Subject: Effects of Environmental and Electrochemical Factors on the Localized Corrosion of Zircaloy-4, Intermediate Milestone 01402.571.020

Responses to comments and suggestions by NRC on IM 01402.571.020 "Effects of Environmental and Electrochemical Factors on the Localized Corrosion of Zircaloy-4"

EFFECTS OF ENVIRONMENTAL AND ELECTROCHEMICAL FACTORS ON THE LOCALIZED CORROSION OF ZIRCALOY-4

Figure 1

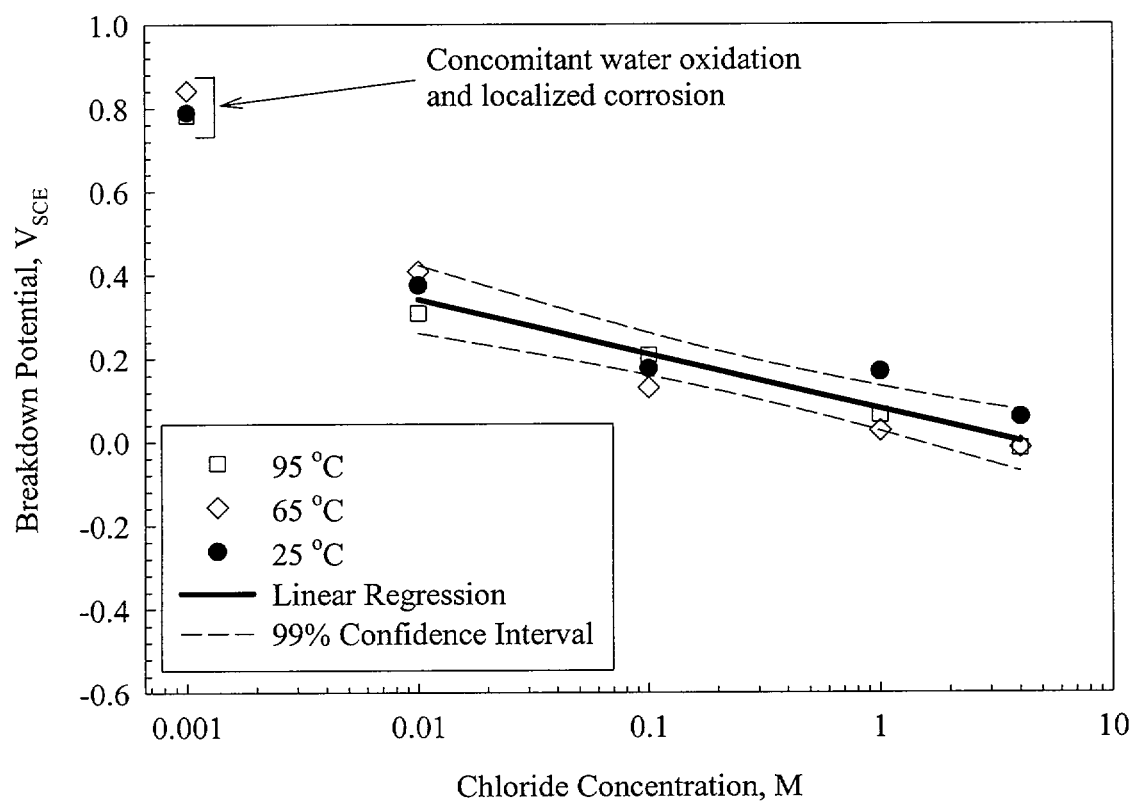
6. Units for figure 1 should be V not mV.

Accept.

Figure 4

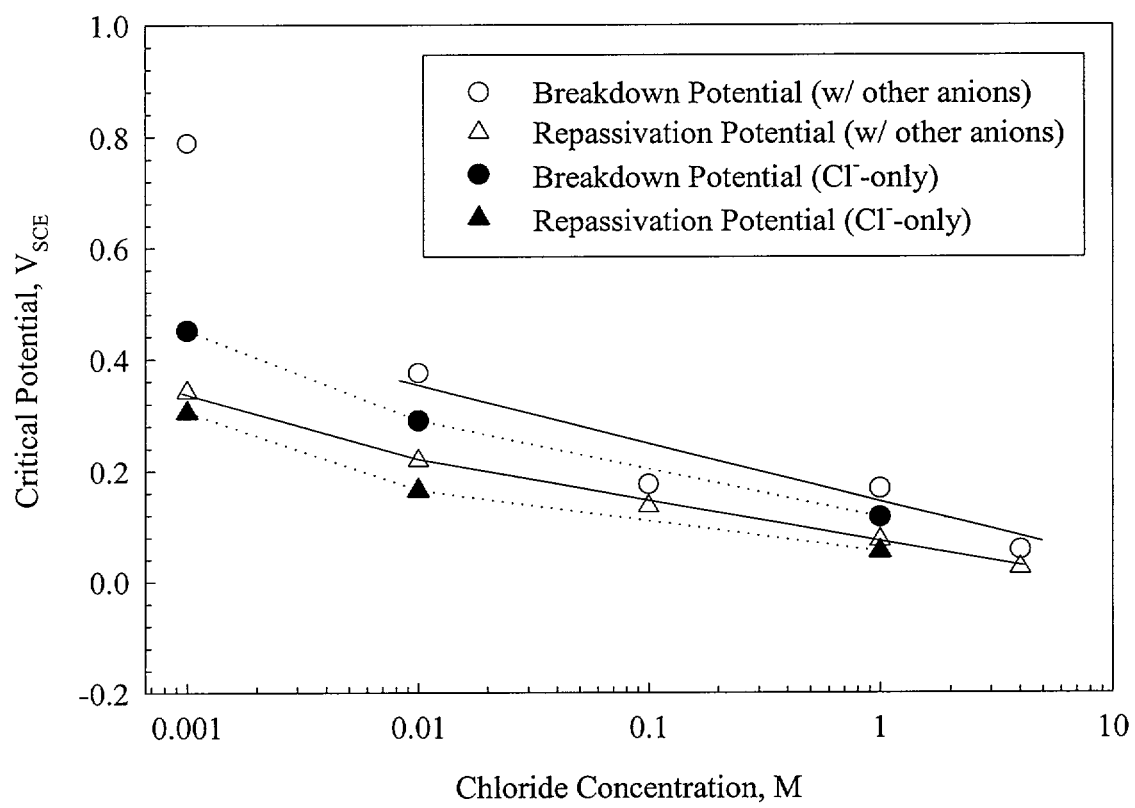
1. The use of the term MGR, as in monitored geologic repository, is not acceptable. Either the authors will need a direct citation for that term, or preferably they should remove all usage of the term. Currently the NRC does not refer to the potential geologic repository as a MGR. MGR is cited on pages 2 (3 times), and page 4 (twice) and in Figure 4 caption.

Accept. See response to Reviewer 1, comment 1.

Figure 7

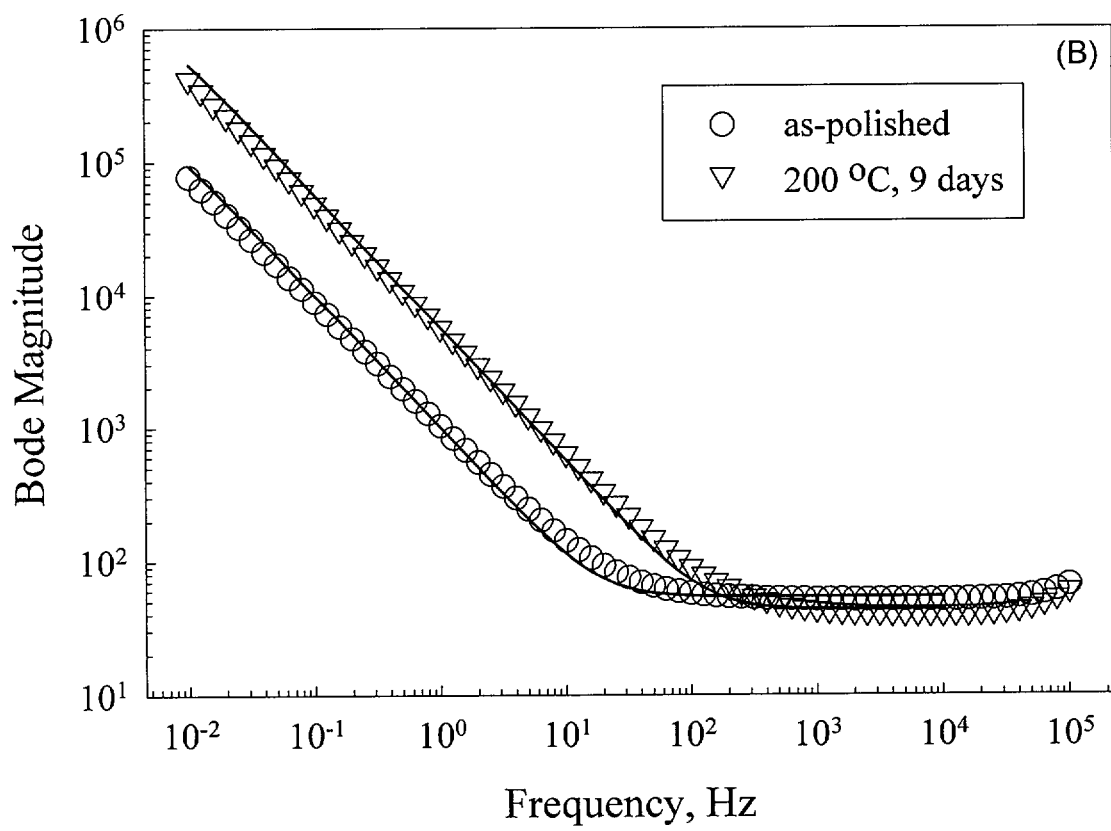
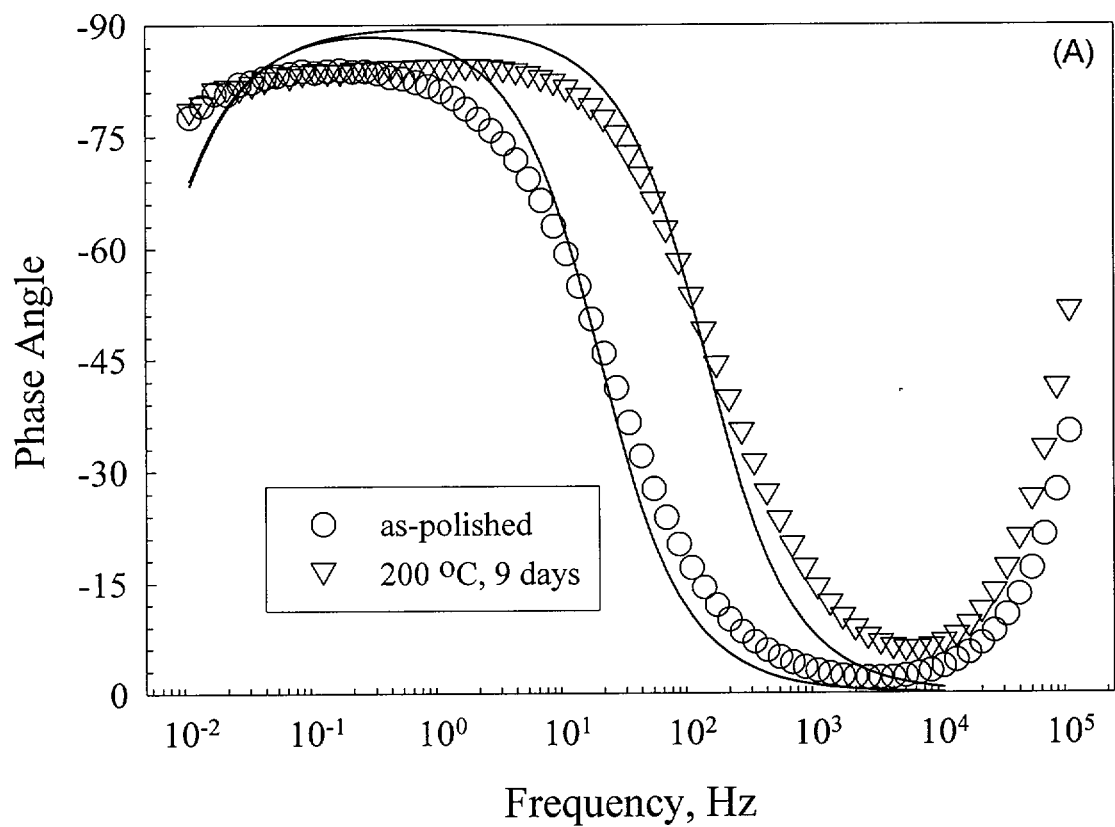
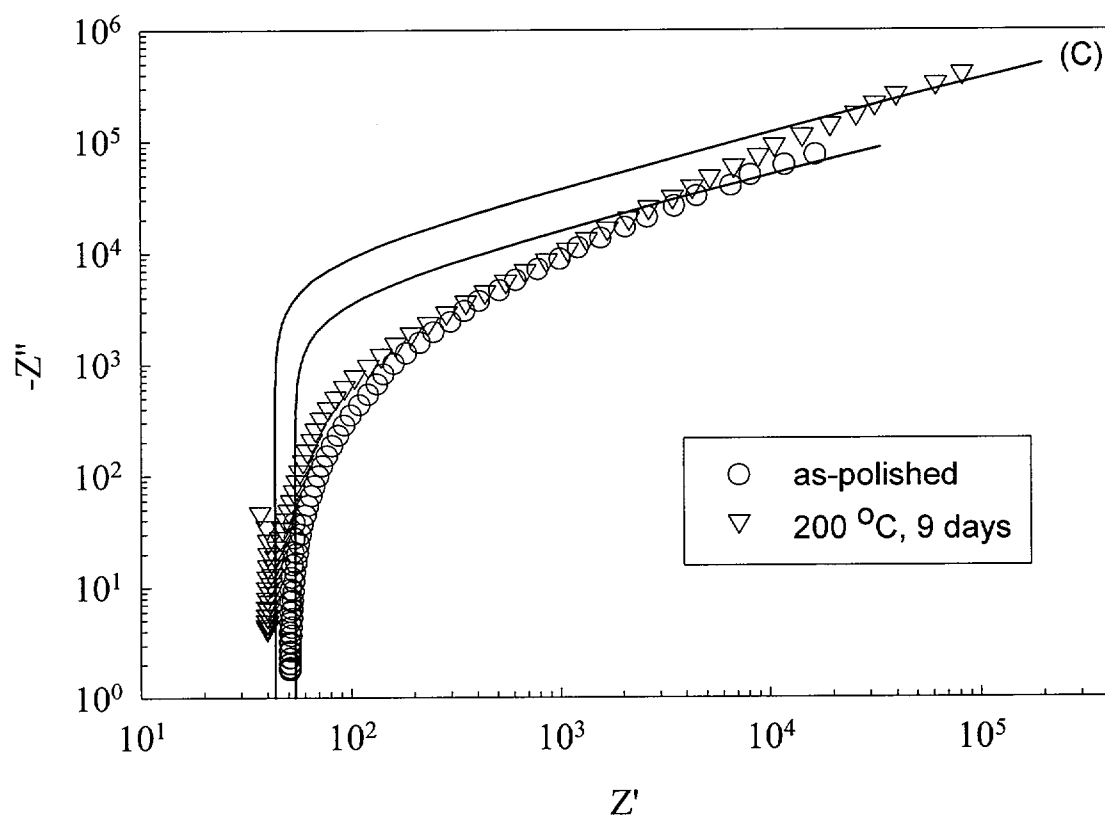
4. I found Figure 7 and its caption to be confusing. I would suggest that the Figure be labeled A, B, and C and the caption broken out to reflect the figure for phase angle (A?), Bode (B?), and magnitude (C?).

Accept. The figure and the caption have been modified.
